**SSI-70610456 Submission on the Exhibition of Critical State Significant Infrastructure:
Hunter Transmission Project**

I object to the application SSI-7061045, for the following reasons:

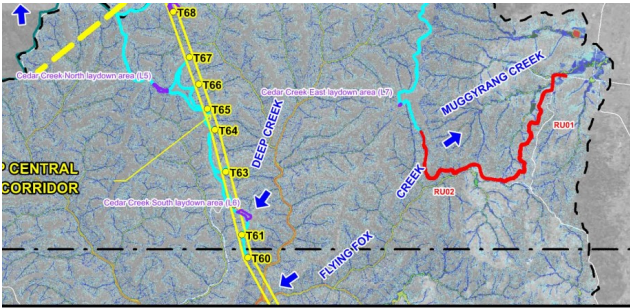
Technical Assessment	Treatment of Pokolbin Mountains Road
Flood Impact Assessment (FIA)	Upgraded along the full length of unsealed road (refer to Figure B.1)  ELEMENTS - Transmission line tower and identifier - New or upgraded access tracks - Road upgrade and identifier - Intersection upgrade and identifier - Construction support site and identifier - Laydown area and identifier - Helpaid site and identifier FLOODIN
Traffic and Transport Impact Assessment (TTIA)	Key Access Road – One water traffic direction for semi trailer and potential two-way traffic for light vehicles with traffic control in place (refer to Figure 5.10)  McDonalds Road PROPOSED PASSING BAYS Pokolbin Mountains Road BROKEN BACK ROAD LAYDOWN AREA PROPOSED PASSING BAYS Oakey Creek Road INTERSECTION ASSES (MCDONALDS RD AND F REFER TO 2583080-CA-) KEY ACCESS ROAD - BROKEN BACK TRAIL - POKOLBIN MOUNTAINS ROAD (TO/FROM BROKEN BACK TRAIL LAYDOWN AREA AND OAKEY CREEK ROAD - 16km). ONE-WAY TRAFFIC DIRECTION FOR SEMI-TRAILER AND POTENTIAL TWO-WAY TRAFFIC DIRECTIONS FOR LIGHT VEHICLES WITH TRAFFIC CONTROL IN PLACE.

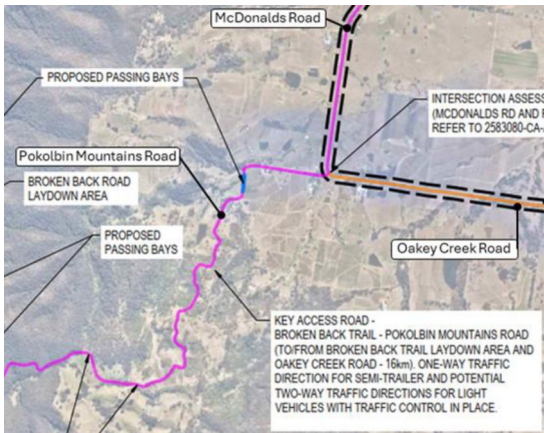
Soils and Land Assessment (SLA)	Pokolbin Mountains Road is identified as an “Access track / access road” (refer to Figure 9.3), however the passing bays are not identified and assessed.  Legend - Operation impact area - Project impact area - Access road / Access track - Construction support site - HTP corridor - Laydown area - Water Features - NPWS Reserves - State Forest BROKE ROAD FIRST CREEK TEATREE CREEK BROKE ROAD LOVEDALE ROAD LOMAS LANE O'CONNORS ROAD NULKABA CAMPBELL CESSNOCK POKOLBIN MOUNTAINS ROAD BROKE ROAD FIRST CREEK TEATREE CREEK BROKE ROAD LOVEDALE ROAD LOMAS LANE O'CONNORS ROAD NULKABA CAMPBELL CESSNOCK

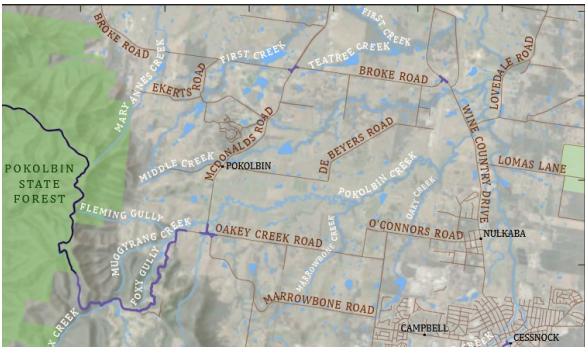
Surface Water Impact Assessment (SWIA)	Not assessed (refer to Figure 2.2) despite the heavy vehicle route and road upgrades proceeding along the full length of Pokolbin Mountains Road. 
Noise and vibration impact assessment (NVIA)	Not assessed (refer to Figure 2.2) despite the heavy vehicle route and road upgrades proceeding along the full length of Pokolbin Mountains Road.  
Air quality and greenhouse gas impact assessment (AQGGIA)	Pokolbin Mountains Road is identified in the Study Area (refer to Figure 3.4) however residential and commercial receptors (including within 50m) of the unsealed section of Pokolbin Mountains Road are omitted from the assessment (refer to Figure B.5).

Figure: Erosion and sediment loss due to drainage constraints near proposed passing bay location on Pokolbin Mountains Road, not identified or assessed in the EIS (photo June 2025) [edited for privacy]

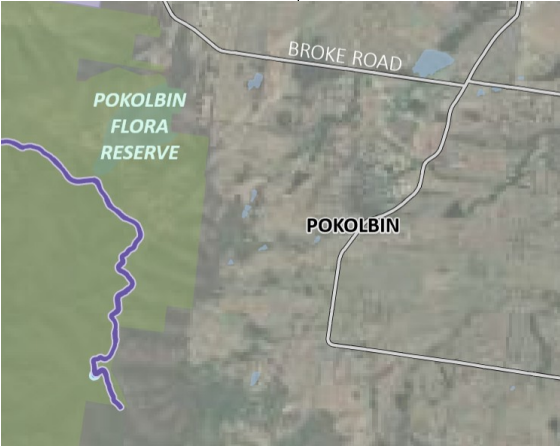
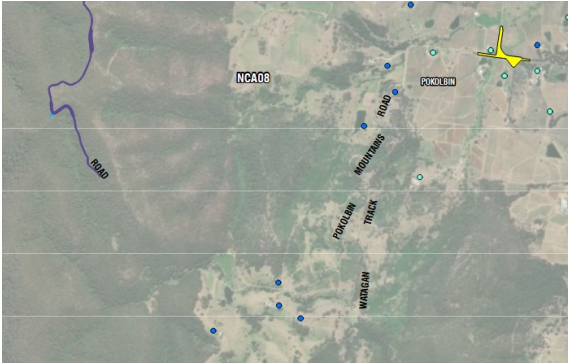
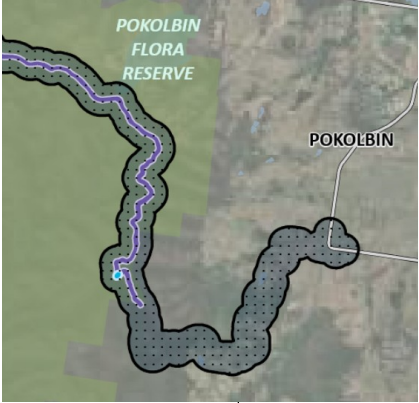
Due to this inadequacy in assessment scope and failure to identify relevant themes in the SIA, the EIS has identified and properly considered the existing constraints in relation to erosion and soil on Pokolbin Mountains Road, The project has the potential to increase the existing erosion and soil loss that occurs due to normal rainfall conditions on Pokolbin Mountains Road, as shown in the photo below.

The EIS must properly define the project in relation to upgrades and passing bays on the unsealed section of Pokolbin Mountains Road so that the impacts in relation to soil and erosion are properly assessed and detailed mitigation measures developed. The assessment must include existing drainage constraints that result in erosion and soil loss.
